ARCHITECTURAL REVIEW BOARD MEETING

PROJECT COMMENTS

PROJECT NUMBER: SP2024-040
PROJECT NAME: Site Plan for 5543 Horizon Road
SITE ADDRESS/LOCATIONS: 5543 HORIZON RD

DEPARTMENT	REVIEWER	DATE OF REVIEW	STATUS OF PROJECT
PLANNING	Henry Lee	09/18/2024	Needs Review

1 PHOTOMETRIC DRAWING - SITE
1" = 25'-0"

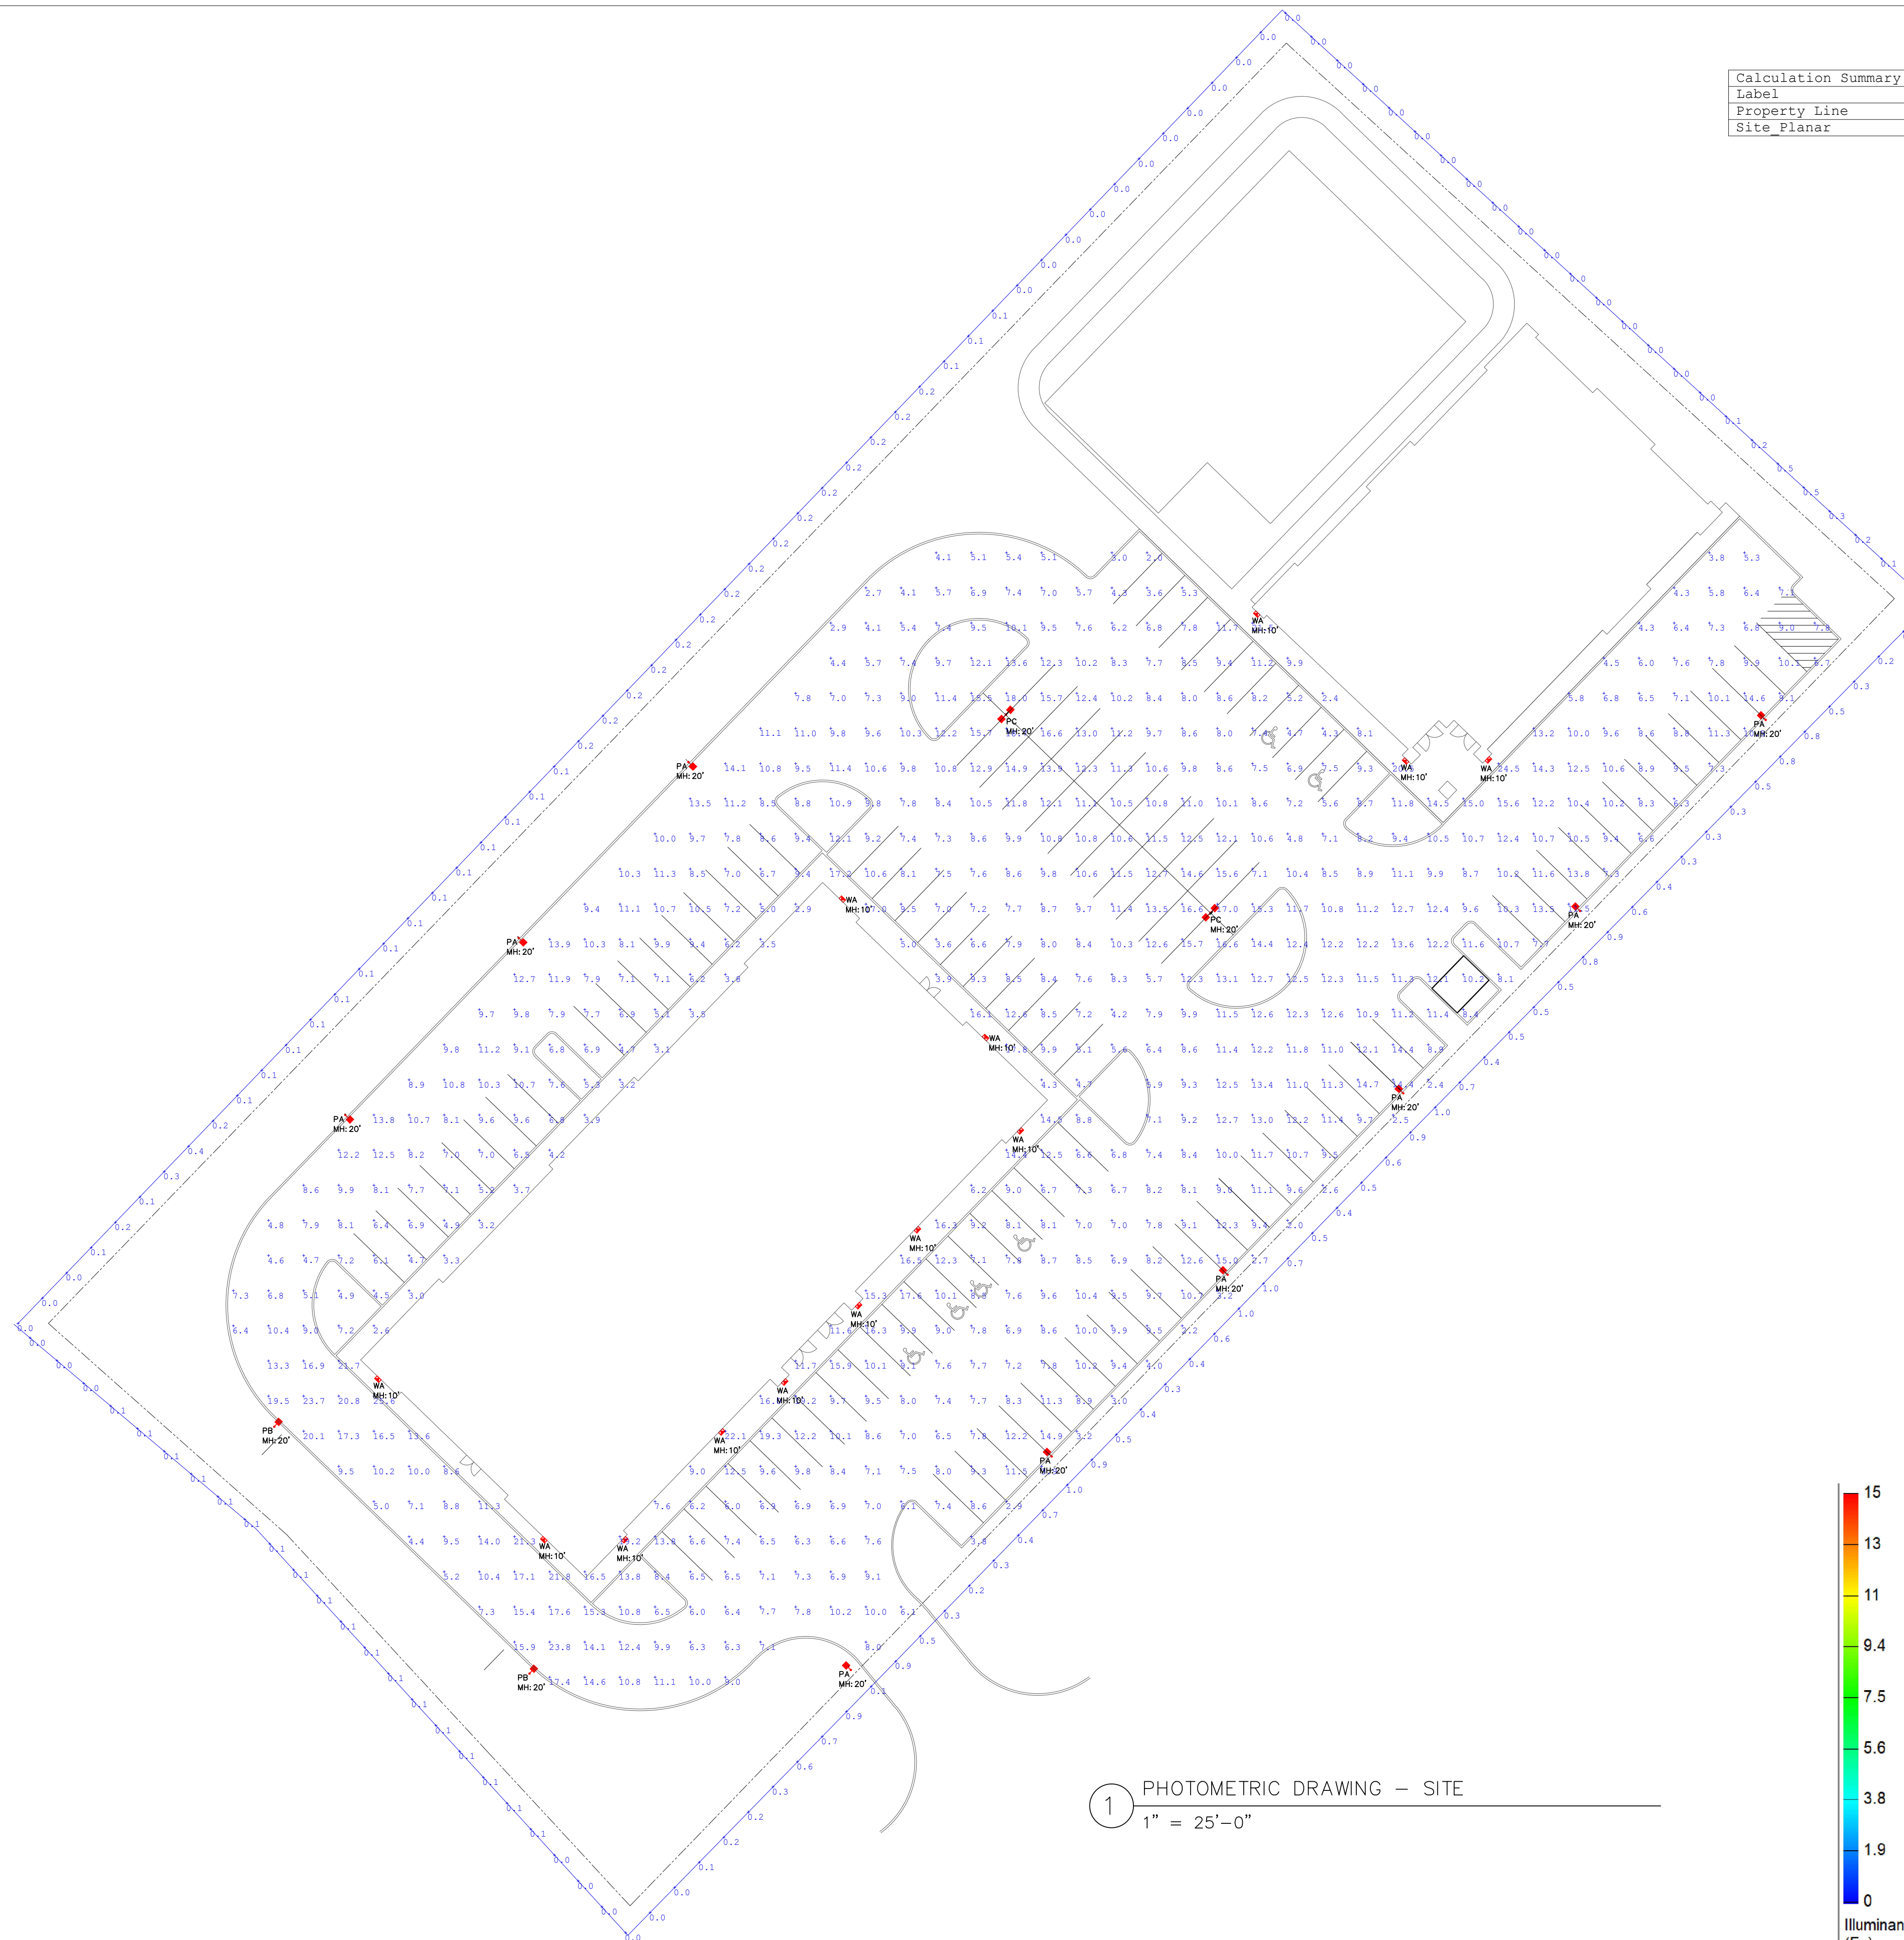
M.9 Photometric Plan

- (1) Provide the same site data information required in Section 2.1 Site Plan: Miscellaneous and Density and Dimensional Requirements of this checklist. (See Sec. 2.1 of the checklist)
- (2) Light levels must not exceed 0.2 FC at the property lines. (Subsection 03.03.G, of Article 07, UDC)
